Change Notice

M Series

Discontinuation of Inactive M Series Toggle Configurations

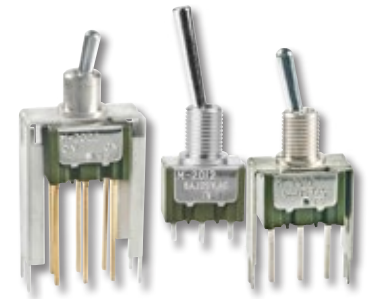
NKK Switches will be discontinuing a limited number of models from the M Series Toggles. This will apply to standard and custom switches, including those with UL and CSA markings. Below and the following page highlight the various options of toggles to be discontinued: those with specific levers, bushings and terminals. Following page 2 are the effected part numbers.

TOGGLE LEVERS TO BE DISCONTINUED			
SMALL TOGGLES		LARGE TOGGLE	
<p>Q .550" (14.0mm) Cone</p>	<p>Q2 .642" (16.3mm) Cone</p>	<p>D .840" (21.3mm) Color Capped Cone Supplied with Cap AT460</p> <p>Colors: Black White Red Yellow Green Blue</p>	<p>R .610" (15.5mm) Large Flatted</p>
BUSHINGS TO BE DISCONTINUED			
<p>D4 6mm/.350" (8.9mm) Threaded with D Flat</p>		<p>LL8 6mm/.295" (7.5mm) Threaded Splashproof with D Flat</p>
